APPENDIX A

SLICE OF DAY RESOURCES

In accordance with Decision (D.) 23-04-010, Energy Division Staff (“Staff”) solicited informal feedback from parties following several Slice of Day implementation milestones throughout 2023. Prior to submittal of the February 1, 2024 Slice of Day Implementation Report, Staff provide this final opportunity for parties to submit informal comments on the various implementation milestones and subsequent material updates. Additionally, Staff appreciate comments on possible implementation barriers and potential solutions.

Figure 1: Capacity Value Lost to Exceedance Translation Step

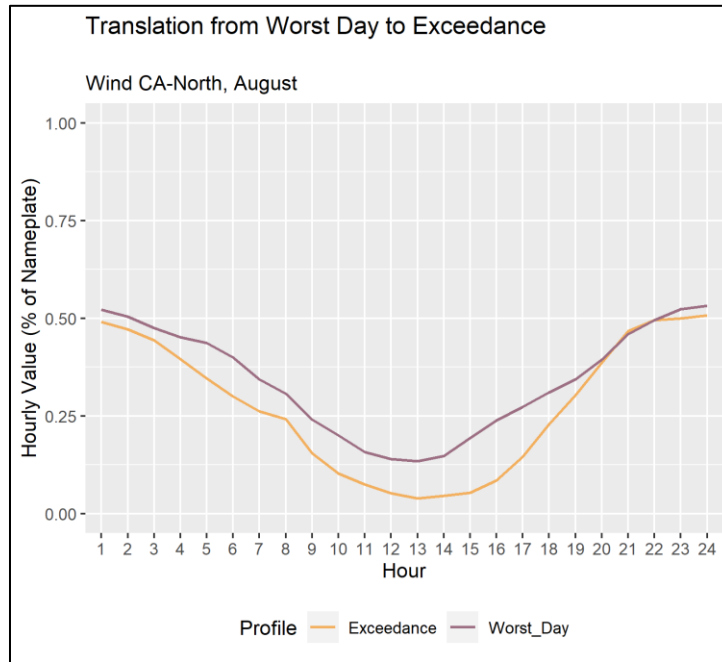
This represents approximately 29% of the wind resources' capacity value in August. The effect is similar for other wind resources, which are illustrated below.

Figure 2: Aggregate Monthly Energy Lost to Exceedance Translation Step by Resource

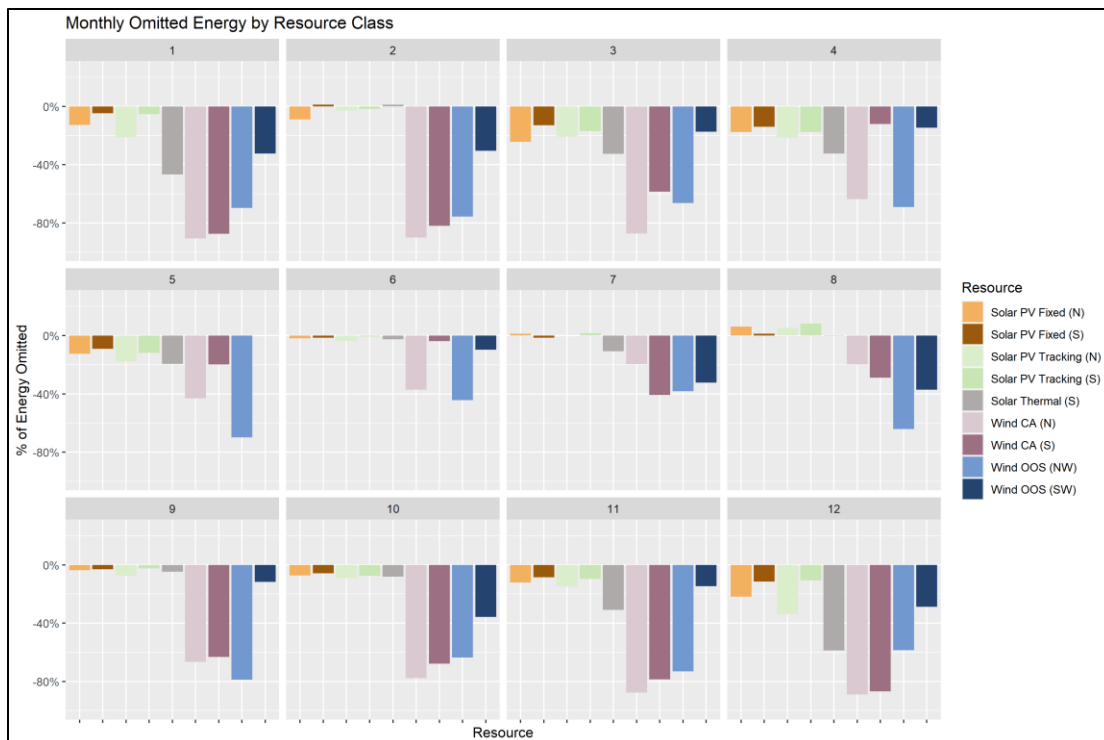
While this effect is more modest with solar resources, it introduces other issues – for instance, tracking solar photovoltaics are valued above their Top 5 benchmark in August.

Figure 3: Comparative Profiles for Tracking Solar Photovoltaics, Southern California

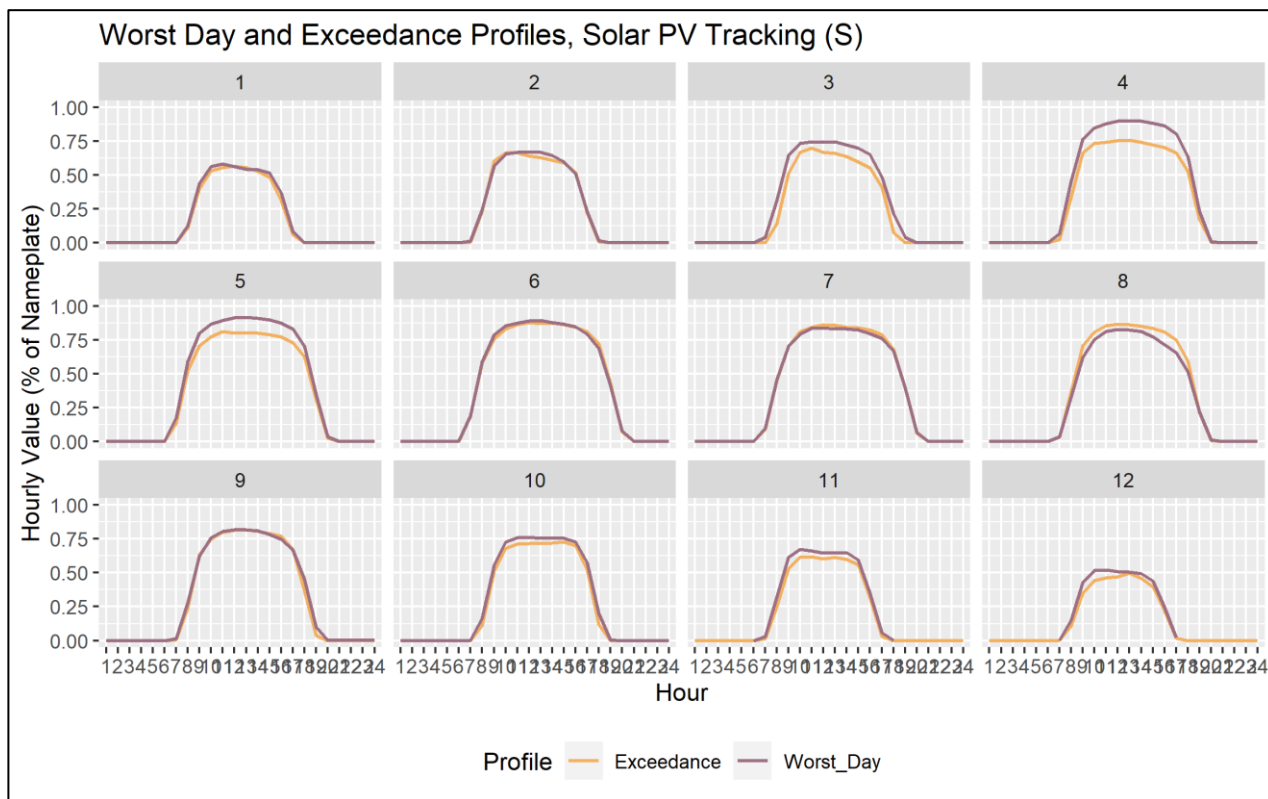
The impacts of lost capacity, particularly for wind resources, may be significant for the system and/or individual LSEs needing energy to charge battery storage resources. While wind resources may produce significant energy on any given day, the variability, which drives low exceedance results, is unlikely to reflect the available energy to the system. This methodology stands in stark contrast to capacity valuation for gas resources, which remain accredited at their full installed capacity rating, excluding both forced outages and thermal derates.

Figure 4: Daily Solar Profiles (August, 2017-2022), with

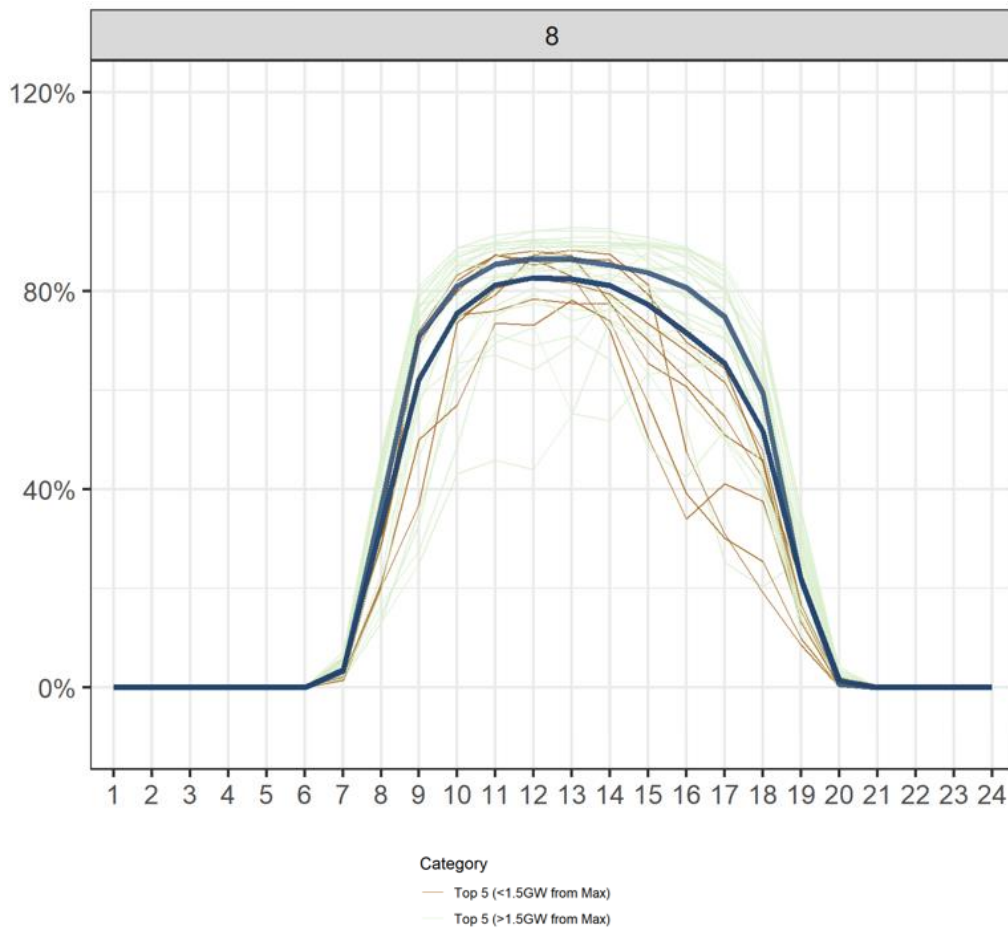
In contrast, Southern California wind in July illustrates a competing trend – while the average of the Top 5 days appears relatively low in morning and evening hours, the highest load days within the dataset are significantly higher than either the Top 5 or exceedance profiles.

Figure 5: Daily Wind Profiles (July, 2017-2022), with Highest Observed Load Observations in Brown

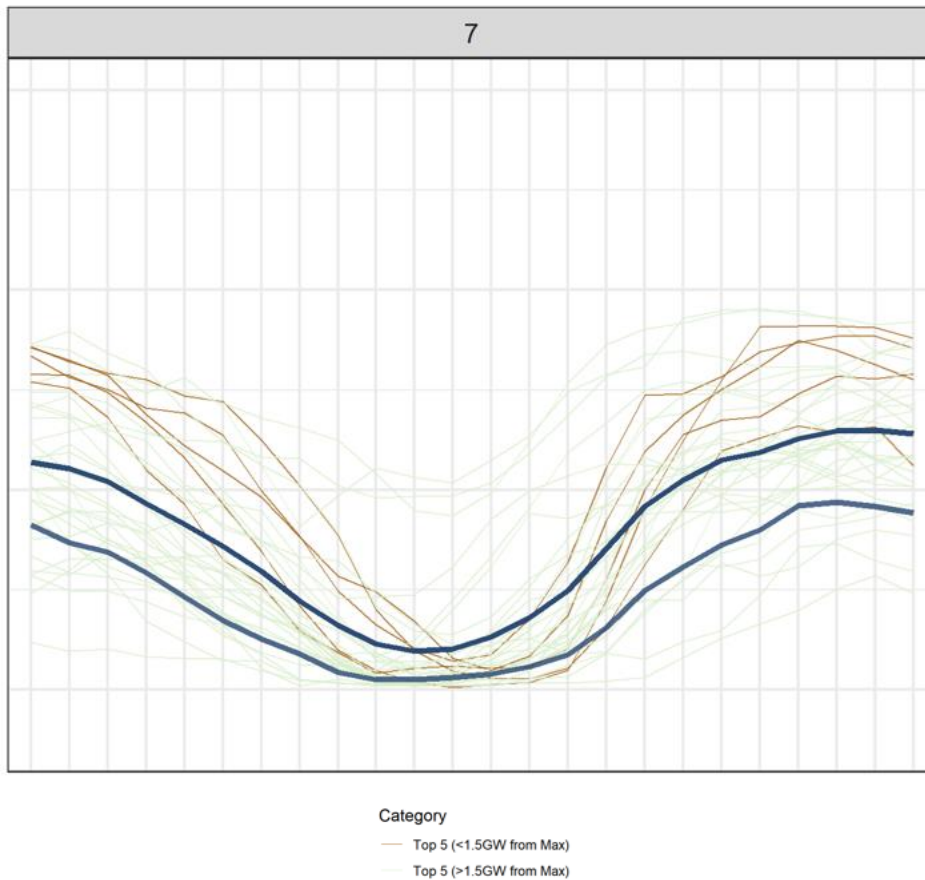
NRDC strongly supports a calibration process by which Energy Division ensures that resource counting rules minimize change to the Planning Reserve Margin as the portfolio changes, as modeled within SERVUM.³ NRDC looks forward to working with the Commission to develop a more robust, durable, future-forward resource counting framework in the next phase of the

Energy Availability Lost to Exceedance Translation

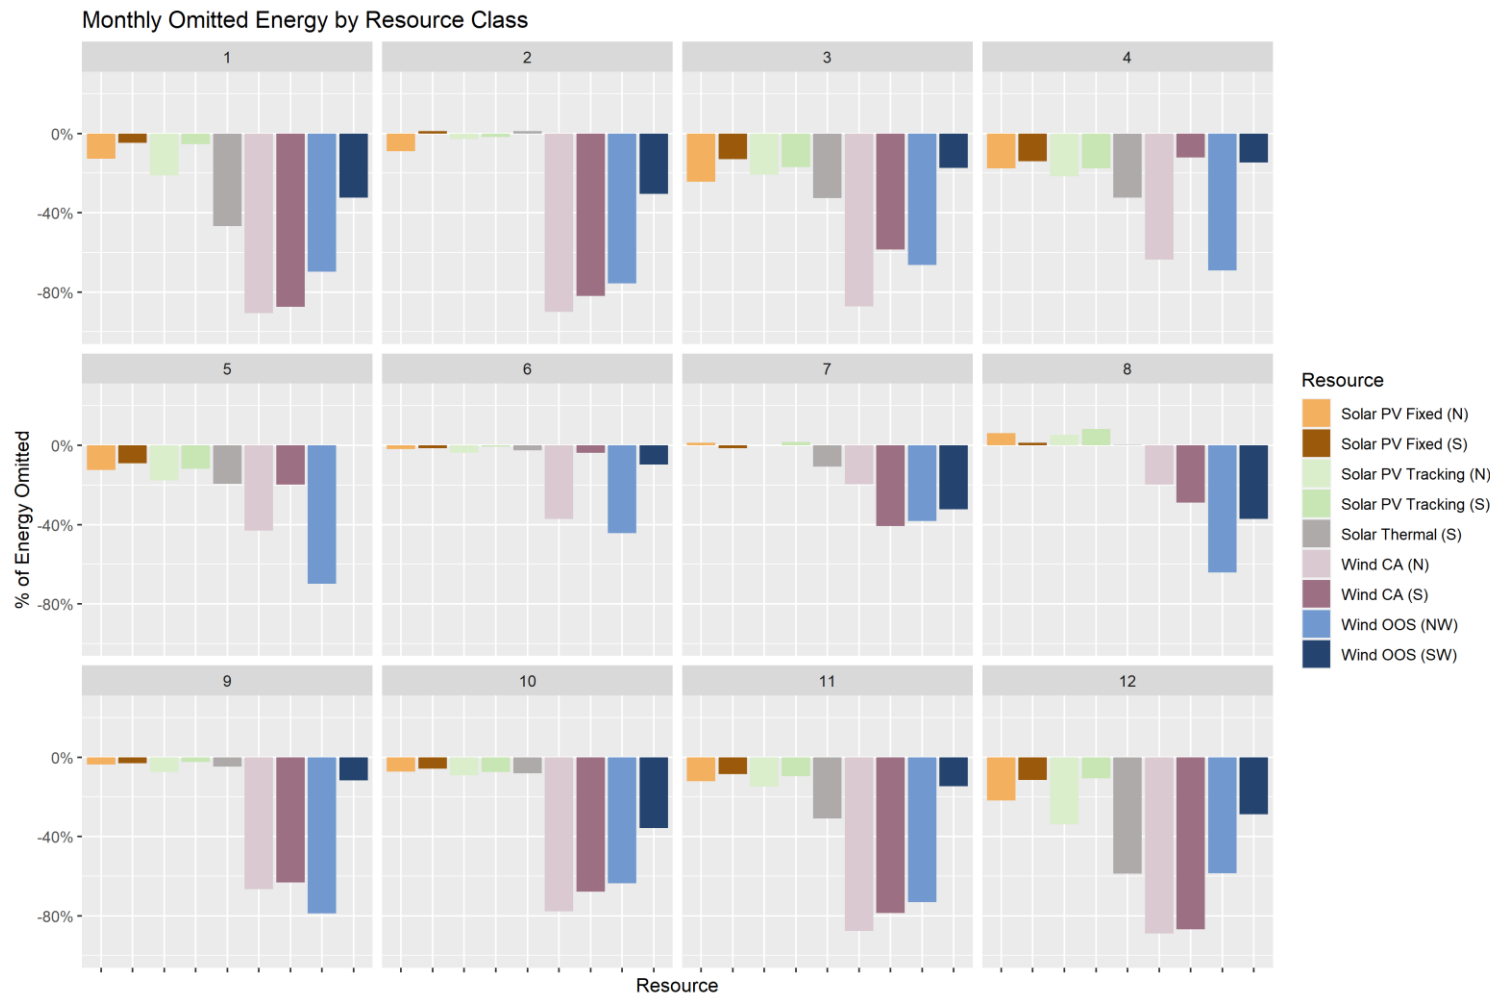
While profile accuracy is reduced for all resources, wind resources are particularly negatively impacted.

Energy Availability Lost to Exceedance Translation

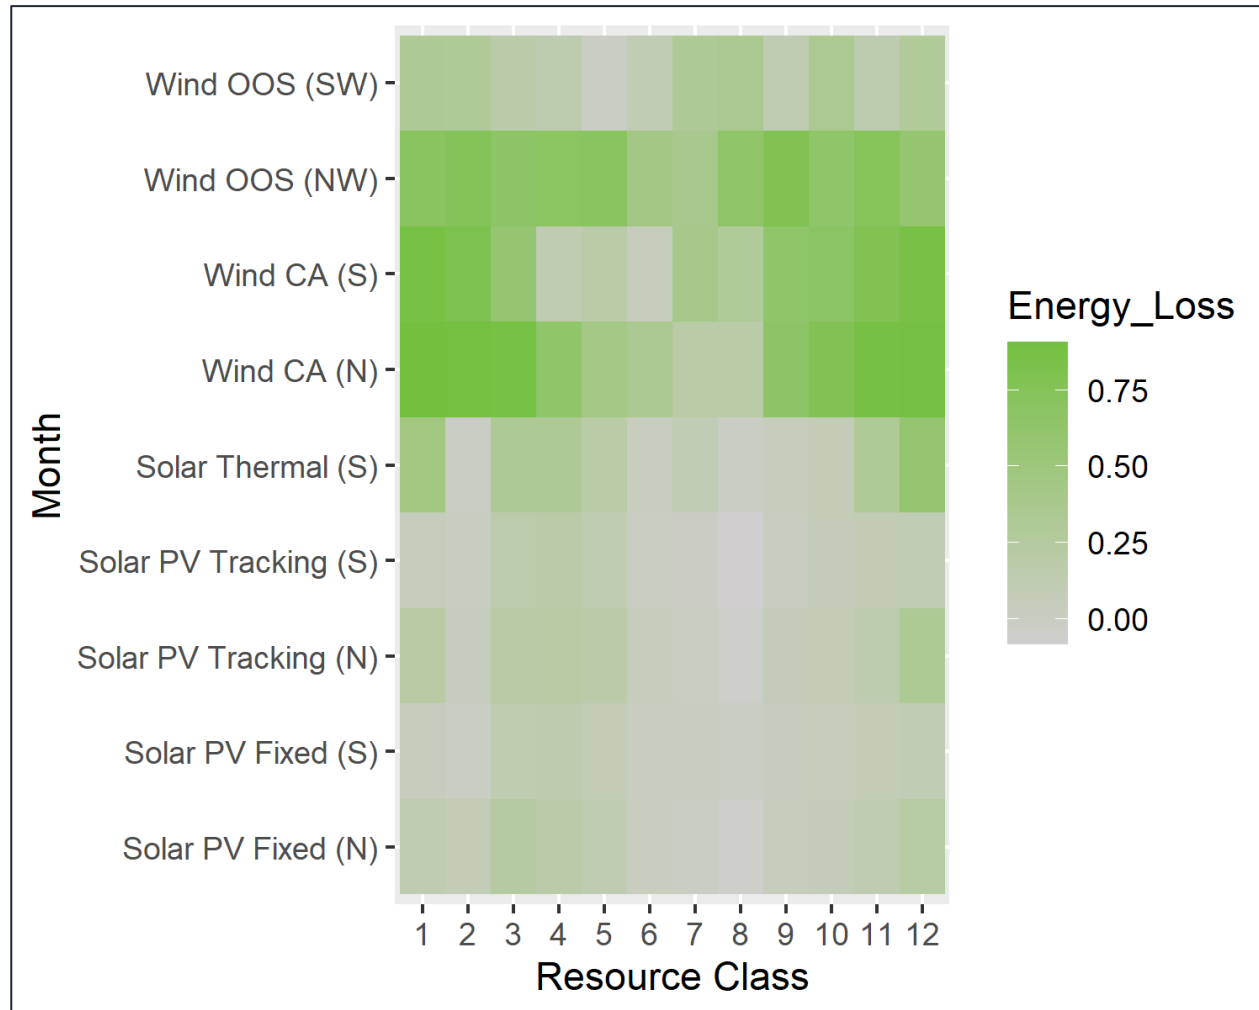
While profile accuracy is reduced for all resources, wind resources are particularly negatively impacted.

**Thermal Resource Bonus
(Desert Star Example)**

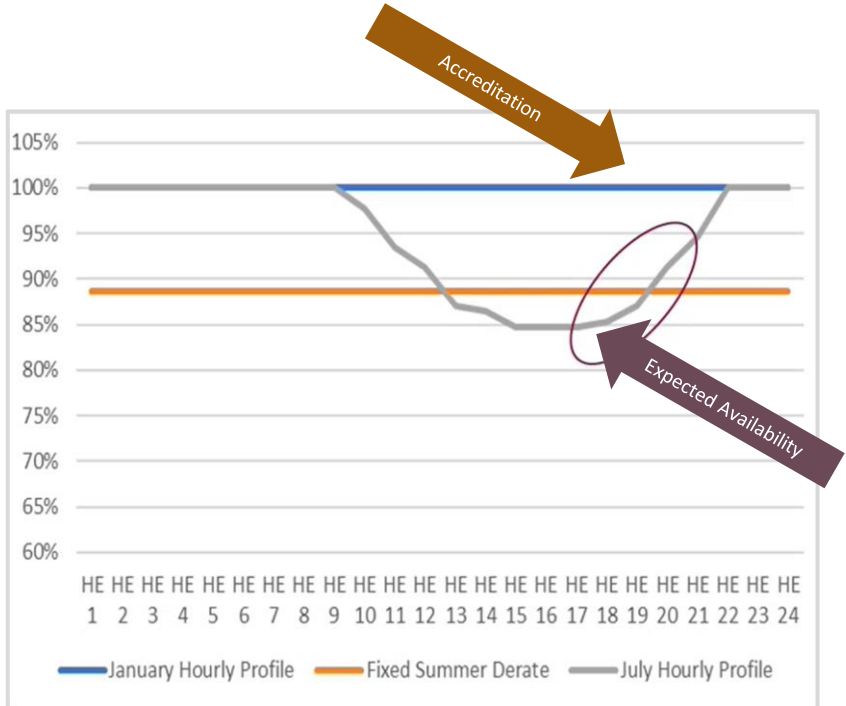
With the exceedance translation, renewable resources are structurally undercounted, while thermal resources continue to receive structural overcounting relative to expected availability as thermal derates and outages are excluded from counting rules (some resources may elect to withhold NQC for thermal derates, but this is not mandatory).

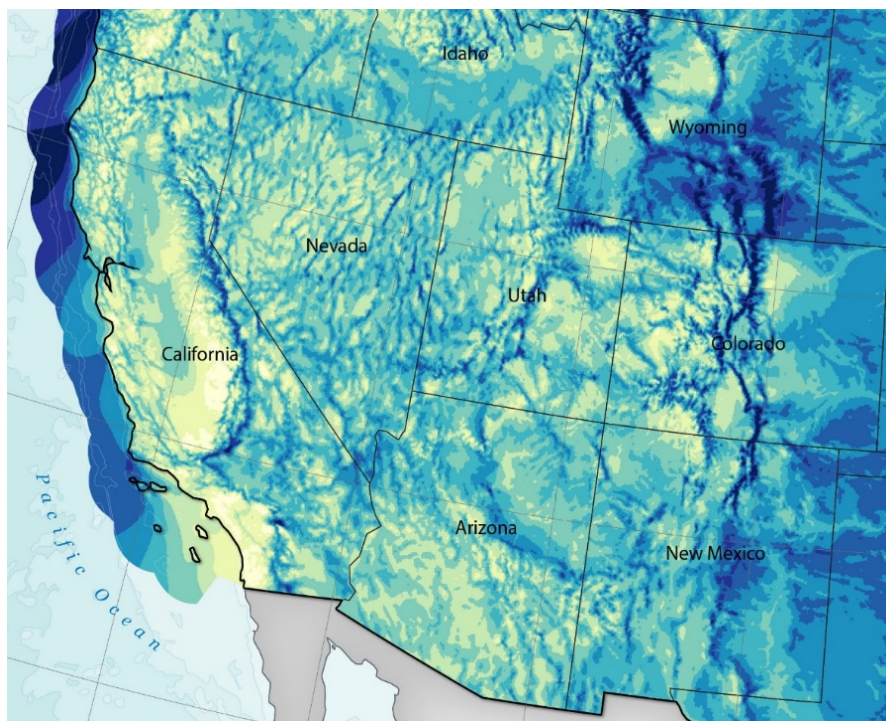
The following map, which is an excerpt of the Southwest portion of National Renewable Energy Laboratory’s (“NREL”) 2017 average annual wind speed shows this differentiation. Higher wind speeds in New Mexico are depicted in dark blue in the bottom right of this excerpt.²

In order to send appropriate investment signals, the Commission should differentiate New Mexico and Arizona. We also request that Energy Division update its analysis of New Mexico wind resources to incorporate the IRP SERVM model data sets to bolster the historical data set in years where there are only a few operational projects.

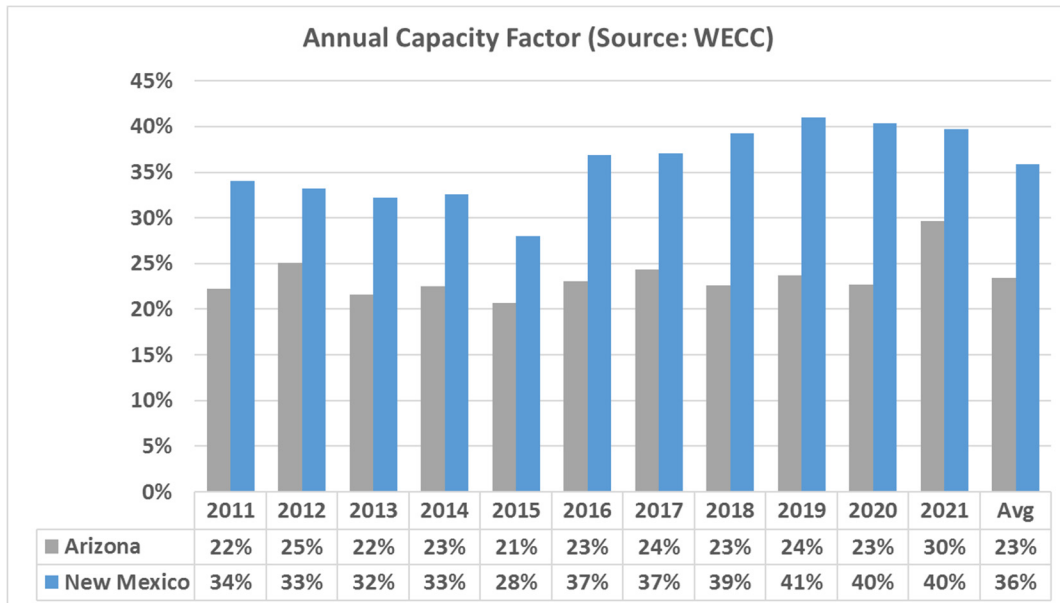
The following chart³ from WECC further illustrates this differentiation between New Mexico and Arizona, the former of which has capacity values nearly double that of the latter.
